THE BOROUGH OF BEDFORD LOCAL ACCESS FORUM (“BOBLAF”)

WRITTEN SUBMISSION FOR DEADLINE 1

This submission provides further information on matters raised in RR-1252, primarily maps relating to the access improvements requested in our Relevant Representation.

APP-121 Figure 2-1b

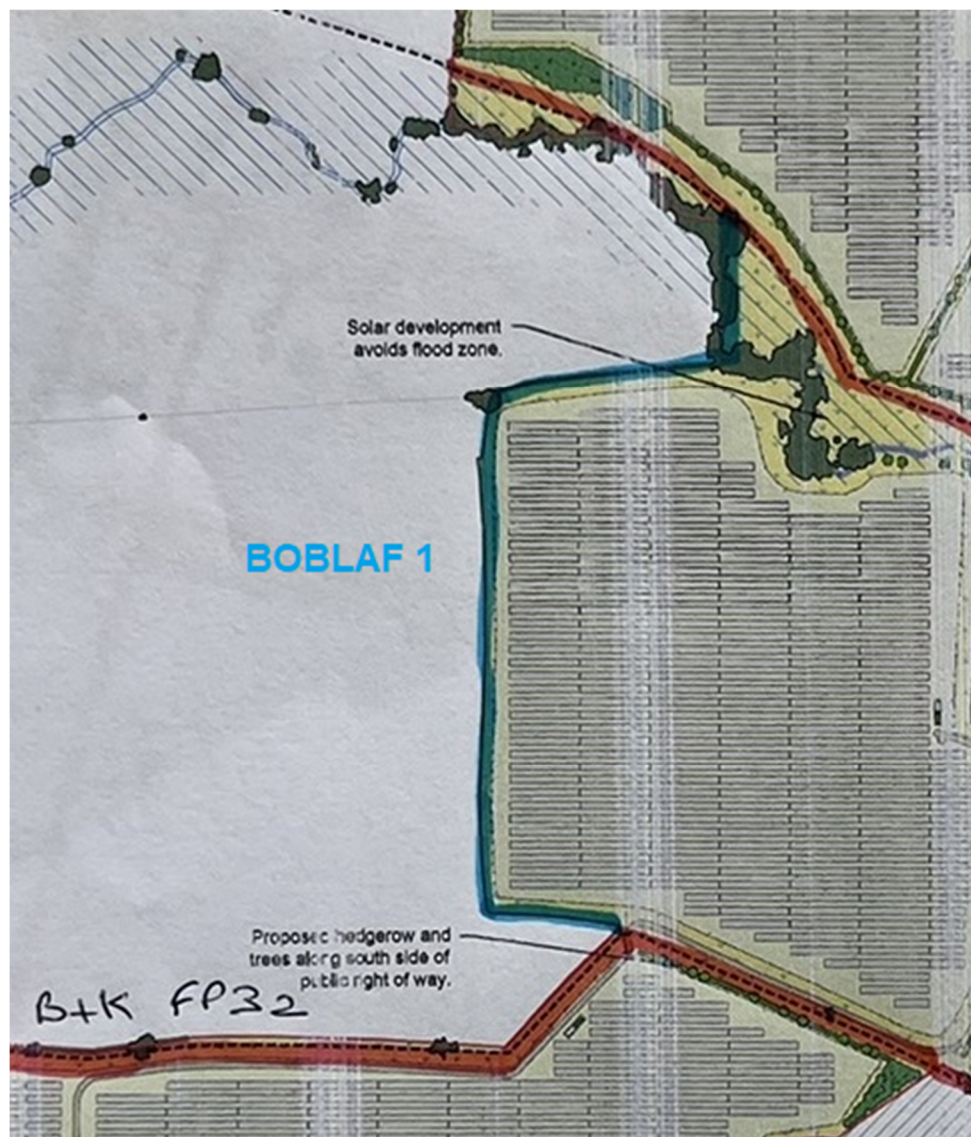
Request 1 - Perimeter route linking B&K FP32 to Pertenhall FP2

This additional footpath, outside the perimeter fence to the west of Site, would provide:

- A connection between the two footpaths, thereby increasing the options for circular walks; and
- Views to the west towards Swineshead, partly compensating for views lost elsewhere

Whilst it would be more pleasant to have hedging between the footpath and the fence, this would not be an absolute necessity.

APP-121 Figure 2-1e

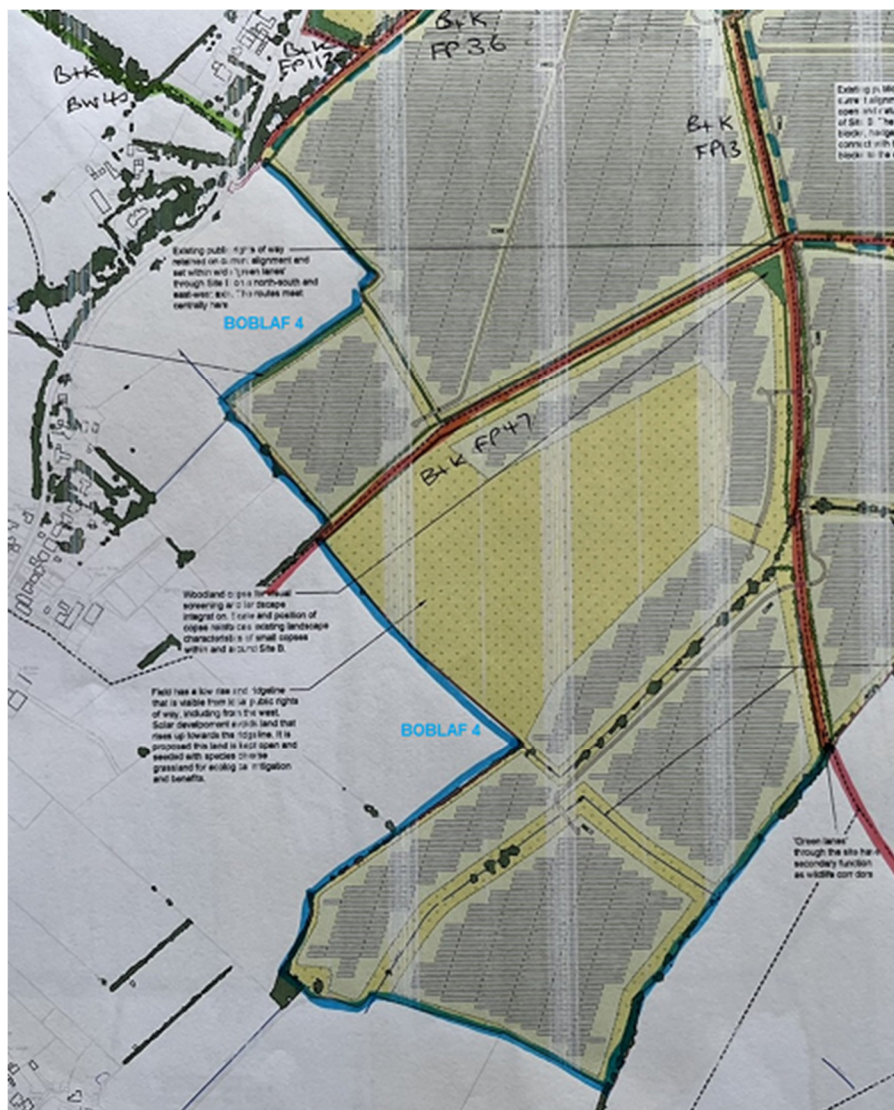
Request 4 - Perimeter route linking B&K FP36 to B&K FP13

This route to the west of Site B would provide

- A connection between these two footpaths and also B&K FP47, thereby increasing the options for circular walks; and
- Views to the outside of the development, partly compensating for views lost elsewhere
- A walk alongside a large area of grassland with the opportunity to observe any wildlife there

APP-121 Figure 2-1d and Figure 2-1e

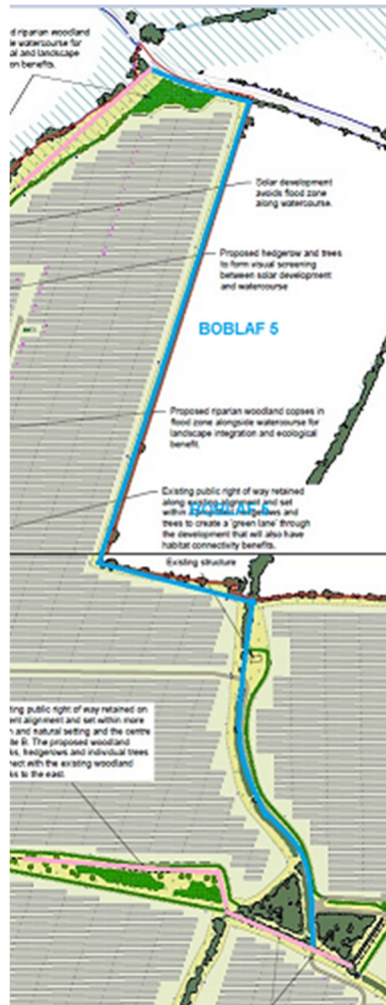
Request 5 - Perimeter route linking Little Staughton FP26 to B&K FP47

Another route that provides good connectivity to achieve a circular walk, particularly beneficial to dog-walkers in the Pertenhall and Keysoe, whilst offering some more open views.

APP-121 Figure 1-2f

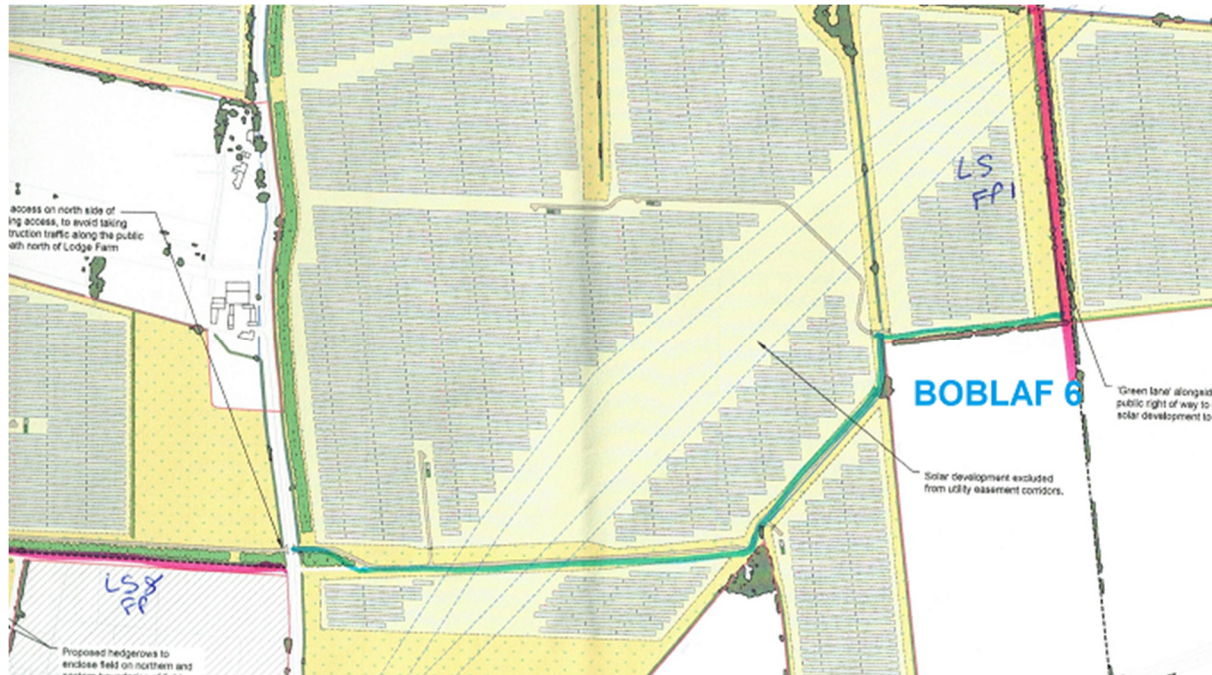
Request 6 - Connection from eastern end of LS FP8 to LS FP1 via site access tracks

At present the connection between these two footpaths is made via the road, approximately 1km on a narrow road with limited verges, one T junction and a blind bend. This connection, through the site, would be much safer even though mostly of site access roads.
